**ASHLAND PLANNING DEPARTMENT  
PRE-APPLICATION CONFERENCE  
COMMENT SHEET**

October 19, 2022

**SITE:** 285-289 Wightman St  
**APPLICANT:** Arkin Tilt Architects  
**REQUEST:** Site Design Review

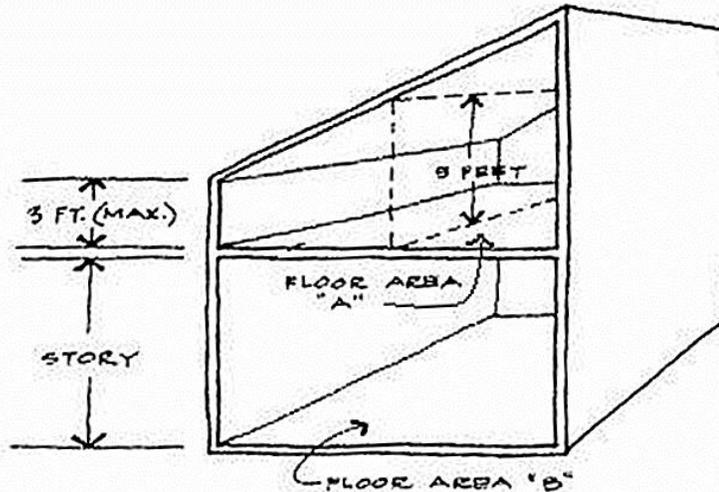
**Generally:** Staff are generally supportive and look forward to seeing this project move forward. As the applicant works to prepare final submittal materials, key items which should be considered include:

Prototypical Section: Residential Neighborhood Collector, Parallel Parking Both Sides

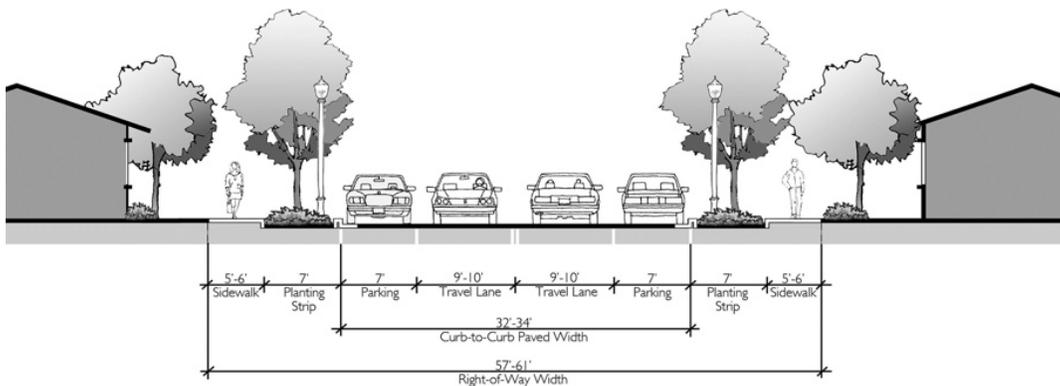
The existing improvement is an approximate 32-foot curb to curb paved width within a 60-foot right-of-way. Site Review typically requires that frontage improvements consistent with this cross-section be provided (i.e. a seven-foot parkrow planting strip with irrigated street trees and a six-foot sidewalk) along the full property frontage and any necessary right-of-way dedicated, or an Exception to the Street Design Standards requested.

Figure 18.3.9.070.B. Building Separation

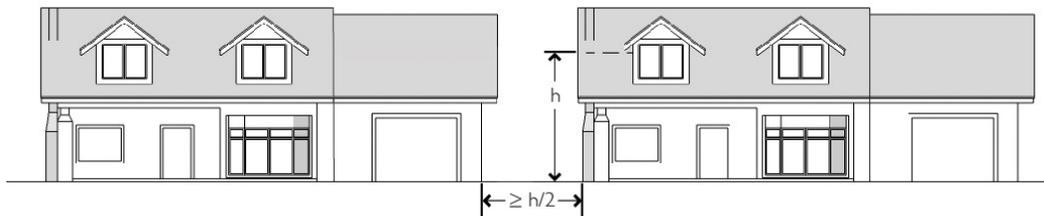
- **Setbacks & Separation (18.3.9.070):** For Performance Standards Options developments, properties are required to meet the front yard setback for the underlying zone, the perimeter setbacks of the parent parcel, solar setbacks and to provide the required separation between buildings (*one-half the height of the tallest building, up to a maximum required separation of 12 feet*) if separated buildings are proposed.

Note: Maximum required building separation is 12 feet.
